CALIFORNIA COASTAL COMMISSION

STAFF REPORT: REGULAR CALENDAR**APPLICATION NUMBER:** 5-01-184**APPLICANT:** Department of Transportation (Caltrans)**AGENT:** Stephanie Reeder, Aziz Elattar, Ron Kosinski

PROJECT LOCATION: Lincoln Boulevard: west side between Loyola Marymount University (LMU) Drive (formerly Hughes Terrace) and Jefferson Boulevard; medians and east side between Jefferson Boulevard and Fiji Way; Westchester, Play Vista, and Palms Districts, City of Los Angeles; and Marina del Rey, Los Angeles County.

SUMMARY OF STAFF RECOMMENDATION:

Traffic Improvements
Certified MDR Ballona LUP

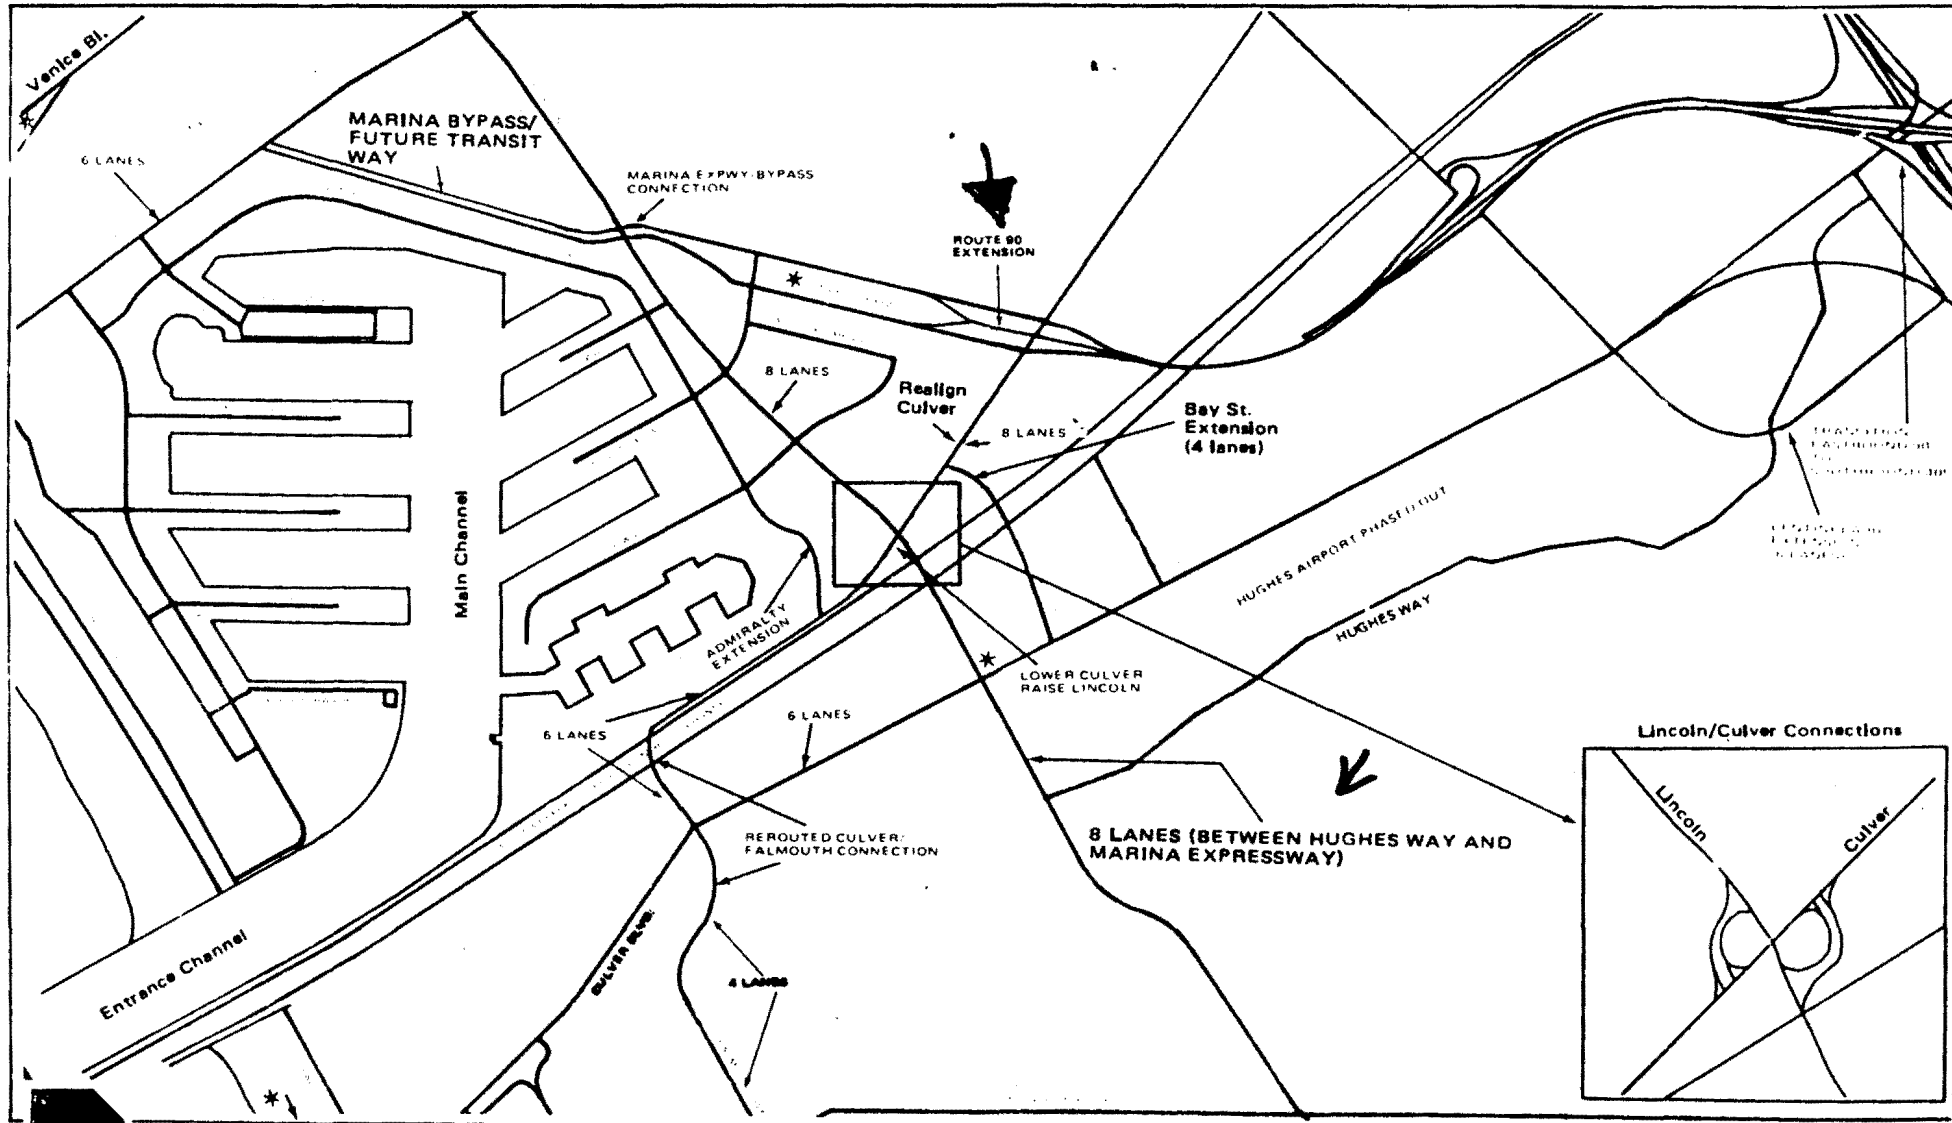
The traffic improvements approved in the Marina del Rey/Ballona plan to accommodate that development included⁶ (Exhibits):

EXHIBIT NO. 3a	
APPLICATION NO.	
5.01.	184
Project Depiction

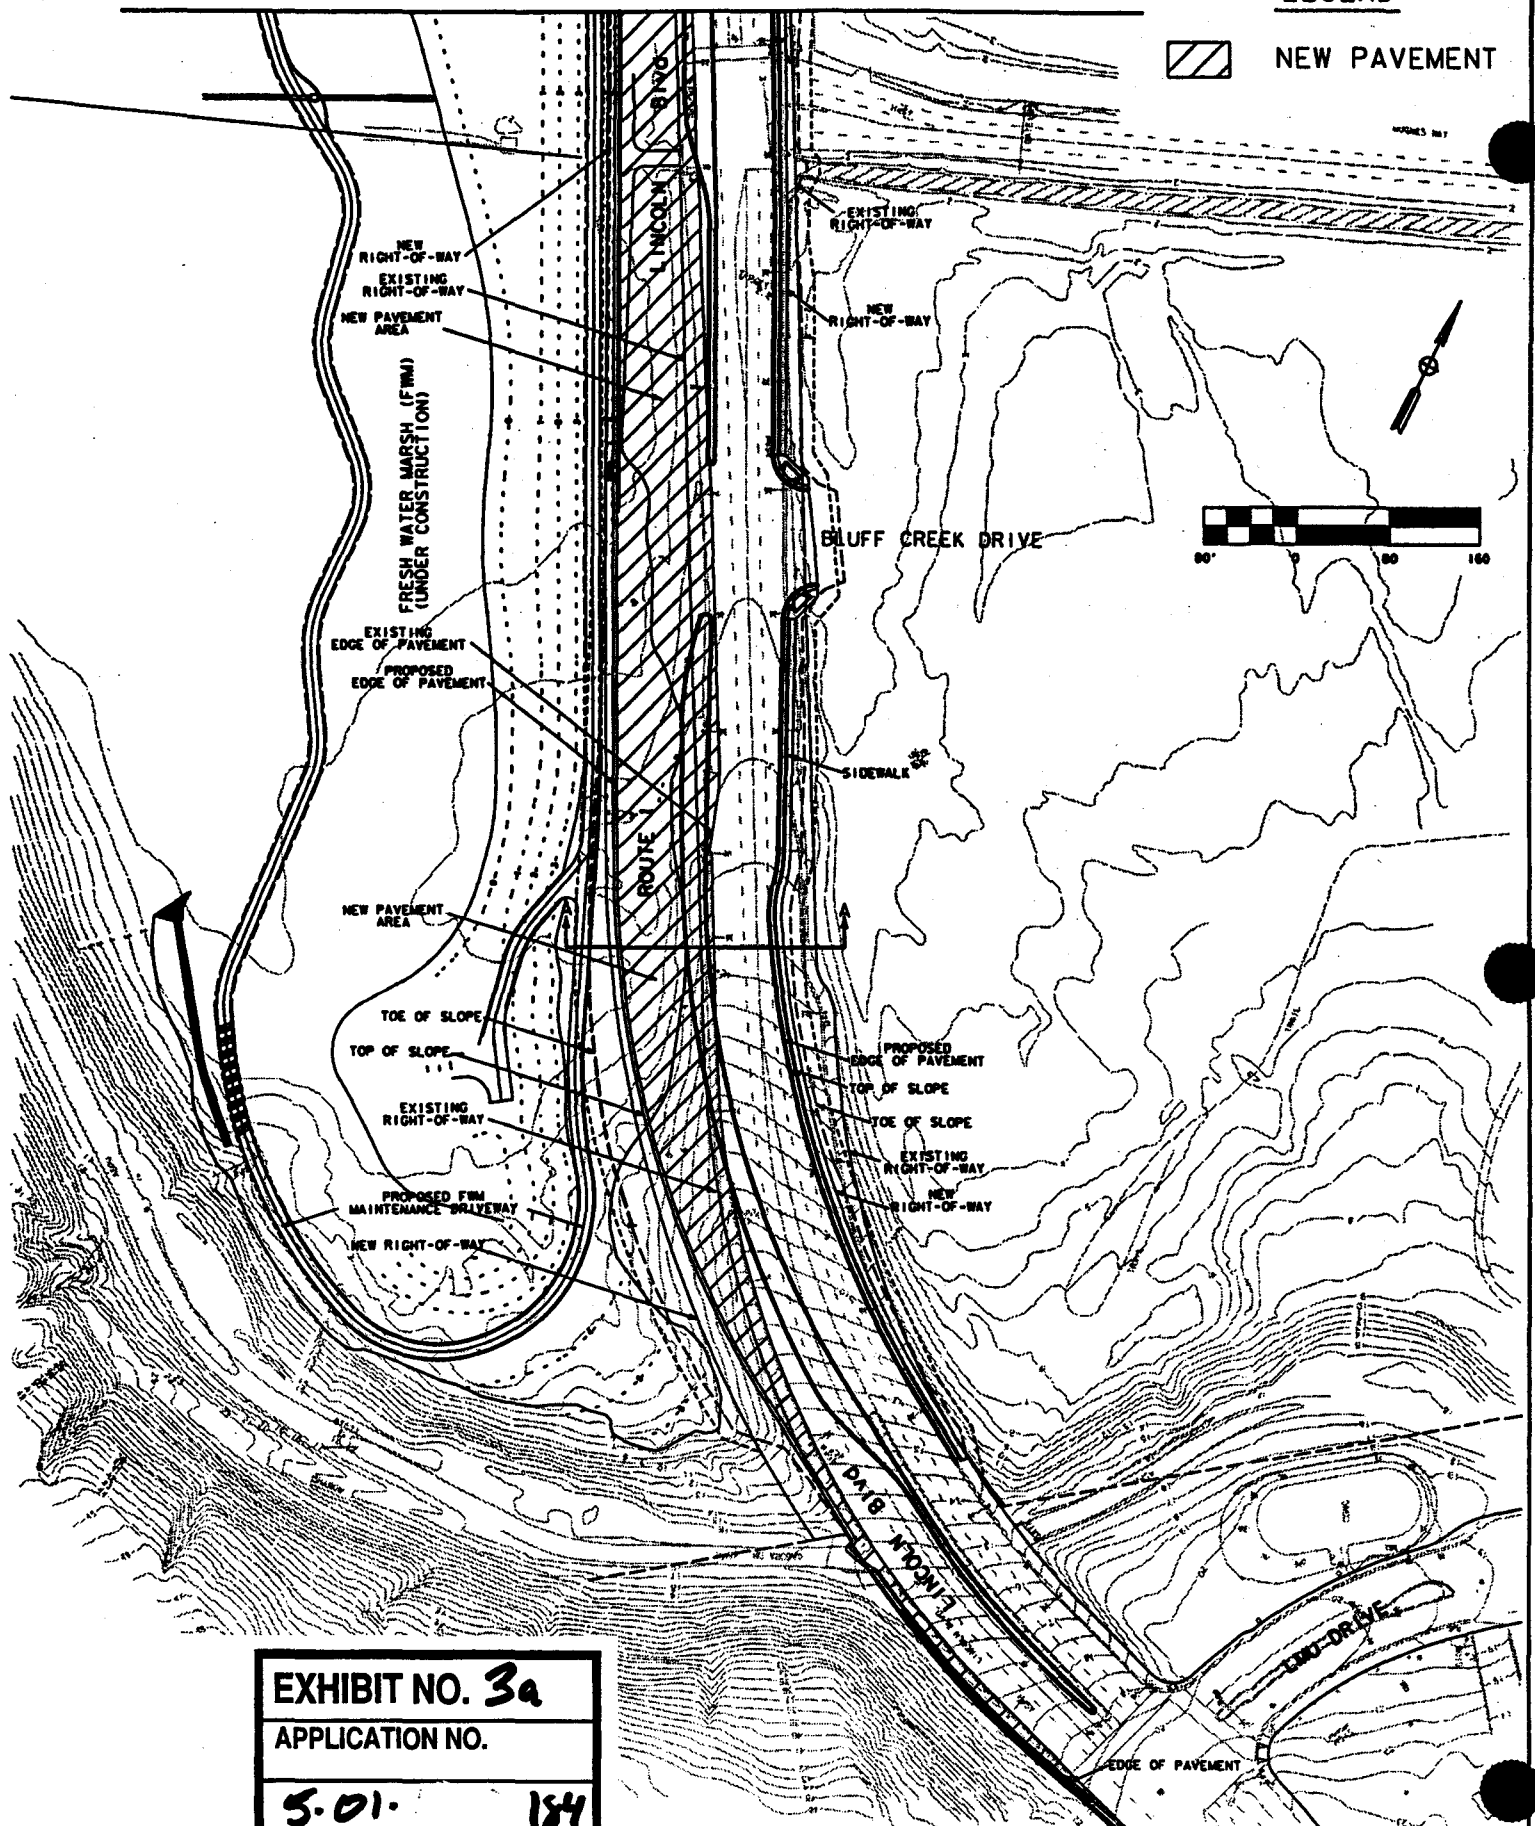
This proposal does not include any foot trails or sidewalks on the west side of the road. The applicant argues that pedestrian access will be provided along the top of the wetland berm, suggesting that a way will be found to allow the public to get up the berm from street level (Exhibit 4). The applicant argues that sidewalks are local responsibilities, but the EIR that required Playa Vista to pay for this road showed sidewalks and bicycle lanes. The bus stops identified in the adopted Playa Vista Phase I mitigation and monitoring program do not appear in the final roadway plan. There are no identified turnouts where visitors can slow to observe the view. This road is as wide as the Long Beach Freeway between the 405 and Willow Avenue, but there is no discussion of measures to adjust timing of lights or otherwise provide pedestrian access across the road. The high speeds for which it is designed will work against its use as a view corridor. The absence of significant landscaping will result in a hot, visually oppressive appearance. As designed, this project does not provide access to the lands adjacent to it and does not provide a recreation support function (Exhibit 3).

In response to these issues, Caltrans has indicated that it will have a four to eight foot shoulder and that part of this shoulder can be paved to provide pedestrian refuges or bus stops. It can also provide a connection to the maintenance road that encircles the freshwater marsh, so that pedestrians can climb up onto the maintenance road, which would then function as a walkway (See Exhibit 4.)
